**LEGAL ADVERTISEMENT
HISTORIC PRESERVATION BOARD
CITY OF PORTLAND
Public comments are taken at all meetings.**

HISTORIC PRESERVATION BOARD AGENDA

**PUBLIC HEARING
38 WHARF STREET**

**PUBLIC HEARING
14 MARSHALL STREET**

A EXISTING ELEVATION
1/4" = 1'-0"

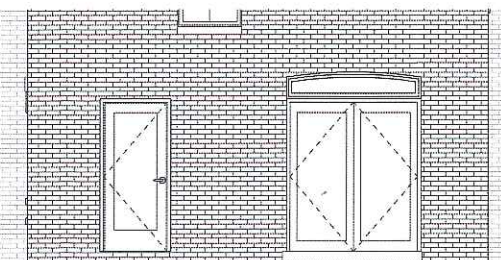
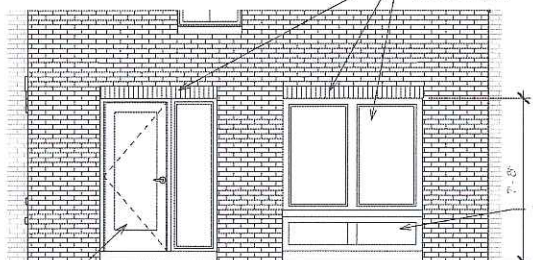
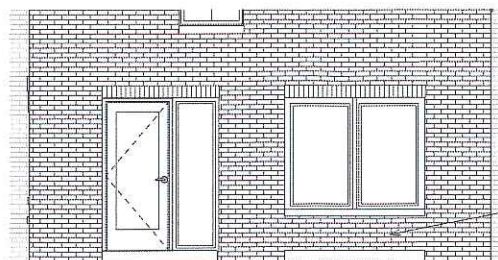
The application includes two options for the modified ground floor treatment. In both options, the existing doorway opening on the left is widened to include a 36" wide, full-lite door with a 24" wide fixed sidelite. In Option 1, the window opening to the right features a pair of mulled 36"x 50" single-lite windows above a frame-and-panel bulkhead. In this option, the frame-and-panel bulkhead would be backed up by concrete block behind it. In Option B, the paneled bulkhead would be replaced by brick infill.

Given the fact that the existing ground floor treatment is not original to the building, a number of otherwise applicable review standards do not apply. The goal is to arrive at a design solution that is compatible with its Wharf Street context, is

appropriately scaled and proportioned for the subject facade and relates to existing storefronts in terms of general organization, material palette and treatment.

In conjunction with the proposed project, staff recommends that the exposed conduit and spotlights above the current storefront be removed and a more compatible lighting solution be installed. Staff will also contact Public Work to inquire about replacing the asphalt patch in front of the entry with infill cobble.

TITLE: Existing
Right Side
Elevation

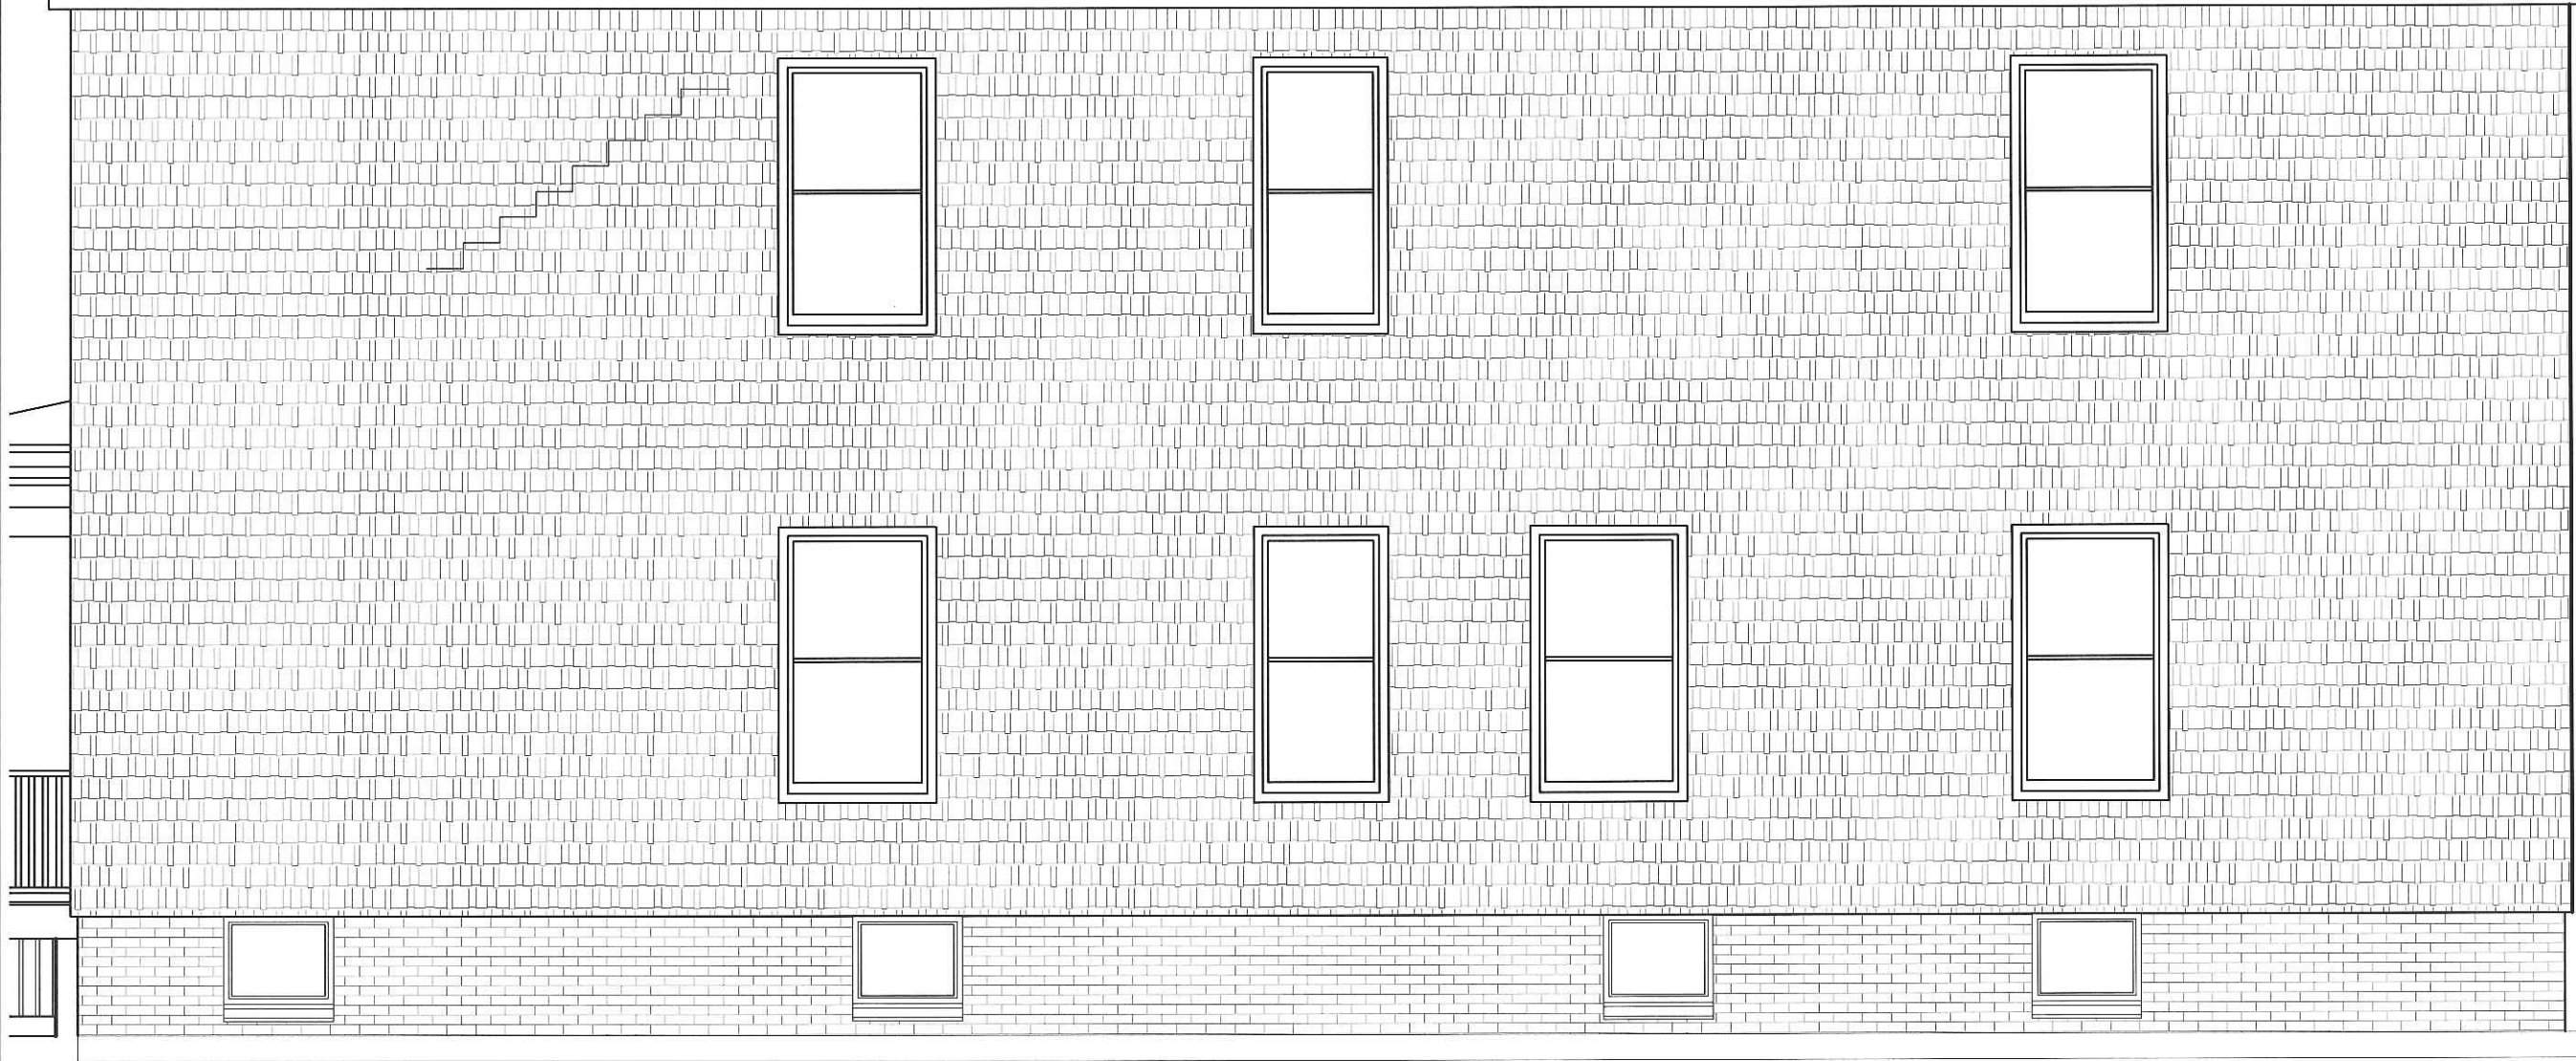
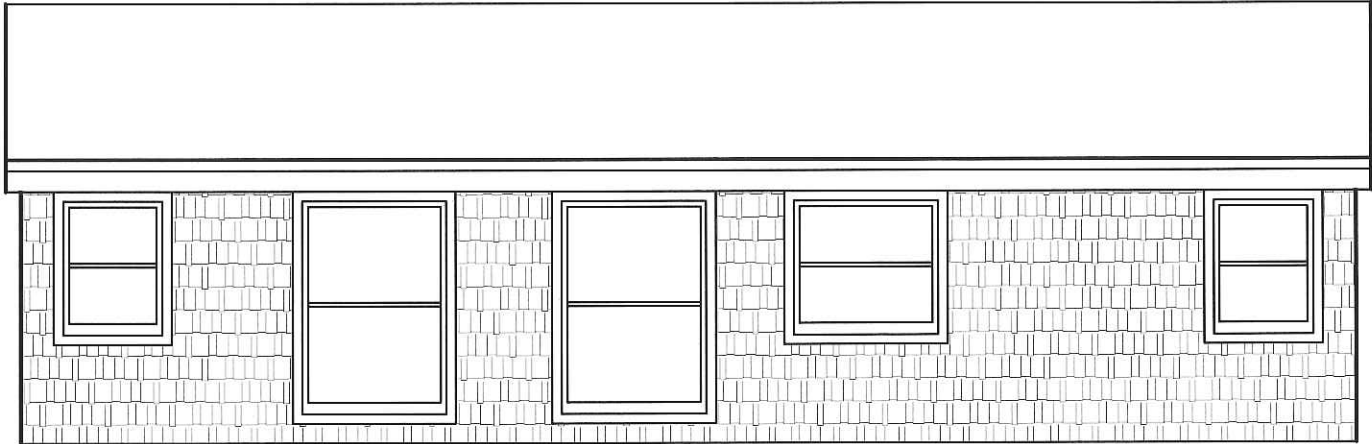
Viewed from the exterior, window placement in the proposed dormer bears little or no relationship to the lower windows in the building, an issue that is probably much more apparent in the elevation drawing than it would be viewed from the street after construction. Staff has raised the question with the designer, who is constrained by the floor plan and design program; but perhaps adjustments can be made. The dormer has three different window sizes, and it would be advisable to introduce more consistency in width and proportion of the openings.

If the Board is comfortable with the concept and form of the proposed dormer, a number of details will have to be submitted for final review:

- Window specifications
- Trim dimensions
- Any venting locations that are not shown on the drawings

VIEW 1 - CUMBERLAND AVE ELEVATION

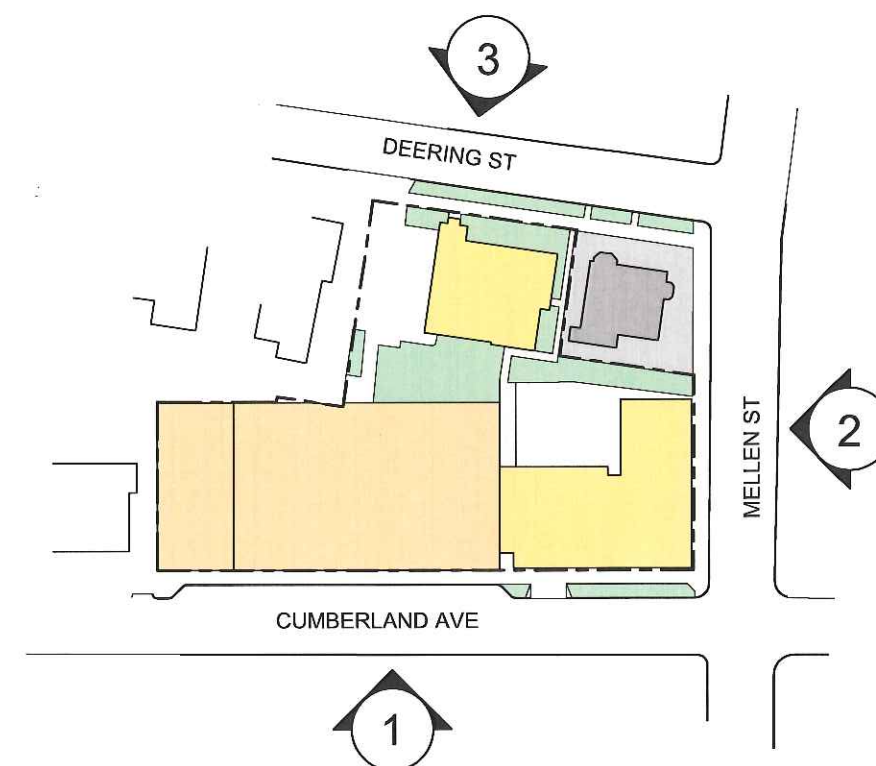
Plans call for a 4-story structure with brick base, clapboard siding and mansard roof. The arrangement of the façade is symmetrical, with the building entrance (which serves as the main entrance for the entire Cumberland Ave. complex) is centered on the addition's façade. The pattern of upper story windows is symmetrical as well, with most of the windows paired. The window pattern is continued in the mansard roof. At the ground floor level, the entrance surround is higher, which provides a clear focal point on this façade. Apart from the entry, the entire ground floor level of the new addition is used for parking. The garage entrance is to the left of the main entrance; paired window-like openings are located on the right side of the entry.

The Mellen Street elevation of the building continues the same basic design vocabulary as the principal facade. Apart from the large window-like opening at the Cumberland Avenue end of the ground floor and the high bank of windows beyond it, the ground floor is mostly blank. The sharp change in grade makes any other treatment of the ground level difficult. A tall window stack appears as a device to break up the continuous façade and provide some visual interest.

VIEW 3 - DEERING ST ELEVATION

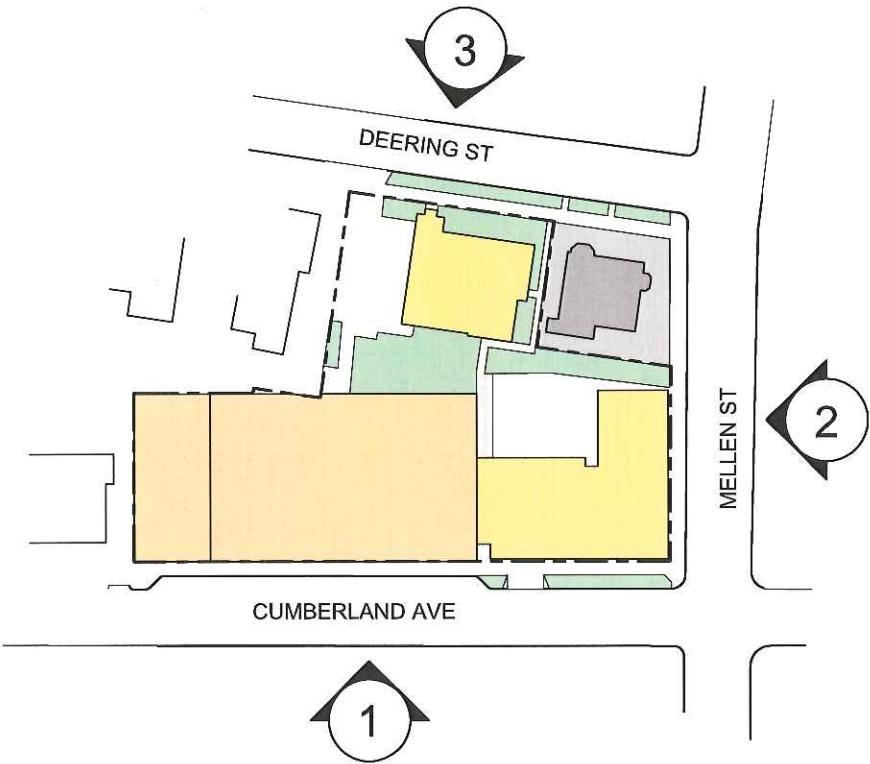
Plans call for the construction of a 4-story, 27-unit residential building. The building features a brick exterior and mansard-type roof. Given the shorter floor-to-ceiling heights, four floors of housing are accommodated in a structure of about the same height as the three-story buildings that flank it. The front façade is set back from the street, consistent with the prevailing development pattern. As proposed, the Deering Street façade features individual, vertically-proportioned punched window openings on the upper floors, some of which are grouped in pairs. At the ground floor level, the building features a raised base, with stairs accessing the raised building entrance. Unlike most of the buildings in this area, the entrance is not centered on the façade. Regular spacing of two first story bays balances the ground floor composition. A beltcourse separates the ground floor from the upper floors, echoing the beltcourse of the neighboring building. Although the brick façade continues across the entire first floor level, this brick façade obscures an open carport for 5 vehicles on the right side of the entrance. Handicap access to the building is from this covered carport.

Staff Comments: Regarding the proposed design solution, it is clear that the design is drawn fairly directly from Avesta's recent Carleton Street project. That said, the general design approach appears to be appropriate for this Deering Street context. The material palette, the building setback, the raised first floor, the modified mansard roof form, the window proportions, the presence of first floor bays etc. are all consistent with the decidedly consistent development patterns of Deering Street. Although the building does not follow the strict symmetry exhibited by its neighbors, in staff's view this is acceptable given the number of other compatibility factors it meets. And although the proposed infill structure's footprint is considerably wider than the buildings immediately surrounding it, wider buildings are not without precedent on Deering Street, as the connected rowhouses at the eastern end of the block reveal.
